OFFICER SOUTH EMPLOYMENT PSP

SUBMISSION ON BEHALF OF THE LUMANOVSKI FAMILY

LOT 2 OFFICER SOUTH ROAD, OFFICER

Figure 2 - Draft Future Urban Structure (subject site highlighted in yellow)

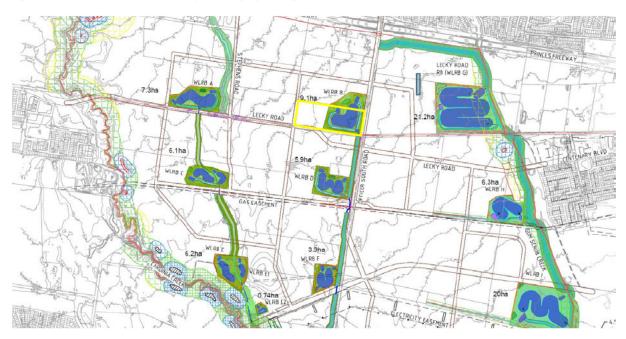
On behalf of our client, we wish to raise issue with the proposed location and extent of the proposed drainage area on Lot 2 Officer South Road, Officer. The proposed drainage area is oversized and unreasonably burdens our client's land.

- There is an opportunity to optimise the MUSIC model and reduce the size of the wetland through revising the conservative impervious fraction and initial storage assumptions for the catchment.
- The wetland is achieving water quality targets well above best practice requirements. The wetland size can be optimised further (area reduced by 24%) and still achieve the water quality requirements.
- Through review of the RORB modelling it was found that the retarding basin is oversized for the catchment it serves by approximately 50% based on peak flow rates.

- Whilst it is acknowledged our client's land is the low point of the catchment, the loss of developable land is not shared equally. The wetland should be reconfigured to be shared across both our client's site and the property to the north (220 Officer South Road, Officer).
- Should the wetland be reduced in size, this reduction in area could be shared between both properties.
- The realignment of Lecky Road creates a parcel of land to the south of the site which could also be
 incorporated into the reserve area. This would provide a functional use of constrained land, share the loss
 of developable land with another land owner and provide access to the reserve area from Lecky Road.

- Option 1B included a combined wetland and retention basin reserve area of 7.81 hectares but was unreasonably dismissed as it was deemed to not satisfy the predeveloped flow criteria at Patterson Road.
- Patterson Road is a long way downstream and there are several factors that can contribute to Option 1B not achieving the predeveloped flow targets at Patterson Road. It is also noted that the preferred Option 1F also does not meet all predeveloped flow targets.
- A reduction in the size of the reserve area has not been given sufficient consideration and needs to be investigated further.
